BROWN REYNOLDS WATFORD ARCHITECTS

ADDENDUM NO. 01

PROJECT: LOS FRESNOS CITY HALL
LOCATION: LOS FRESNOS, TEXAS
PROJECT NO: 217072.00
DATE: June 26, 2018

Re: Supplementary Letter – Stiffened Slab-on-Grade Foundation Option
Los Fresnos Municipal Complex
Highway 100
Los Fresnos, Texas
Gessner Engineering Job No. 17-0424

Stiffened Slab-on-Grade

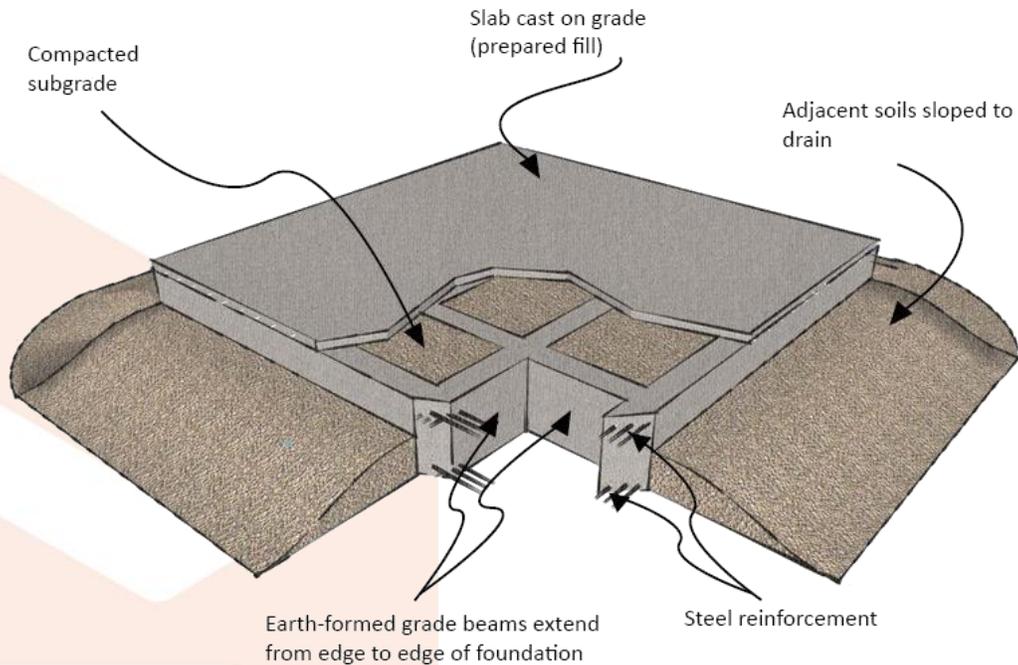
A stiffened slab-on-grade, also known as a waffle slab or modified mat foundation, consists of a slab stiffened with beams spanning across the foundation in each direction. Stiffened slab-on-grade foundations are appropriate for foundations on expansive soils that are sensitive to deflection. Grade beams in these foundations should extend from edge to edge across the slab. The network of grade beams is intended to create a rigid plate that moves as a unit in response to soil movement.
